BRANCH SERVICE MEMO NO. 710 CS

DEALER SERVICE MEMO NO. 397

TO:	All Branches and Chain Saw Dealers		
SUBJECT:	Cylinders and Crankcases	DATE:	1/6/69
UNITS AFFE	CTED: XL101, 2, 3 and 4

SUBJECT: Sealing Compound "Duxseal" used to prevent entry of DATE: water into starter rope area

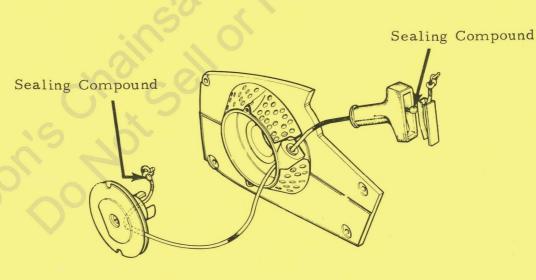
A small quantity of sealing compound added to each end of the starter rope will aid in preventing the entry of water into the rope area.

The sealing compound should be placed around the rope next to the knot at the pulley end and around the rope next to the rope retaining insert at the starter rope grip end. Note the sketch.

The part number for the sealing compound is 24352.

TO: All Districts, Branches and Chain Saw DealersSUBJECT: HL261A Carburetor Part No. A65717

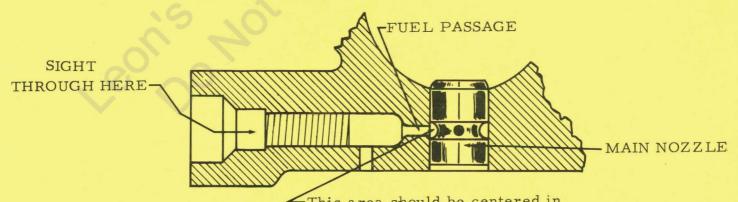
Investigation of why some of these units are running lean, causing premature engine failure, has revealed an improperly located fuel passage supplying fuel to the main nozzle.

To inspect for this condition, remove the high speed adjusting screw. With the aid of a light look in the high speed adjusting hole observing if the top portion of the outside wall of the main nozzle protrudes into the fuel passage.

Note the sketch below and the relationship of the main nozzle to the fuel passage.

This area should be centered in relationship with the fuel passage

If it does, disassemble the carburetor. Using a small punch, drive the main nozzle one thirty second of an inch below the surface. This will properly locate the groove in the main nozzle with the fuel passage.
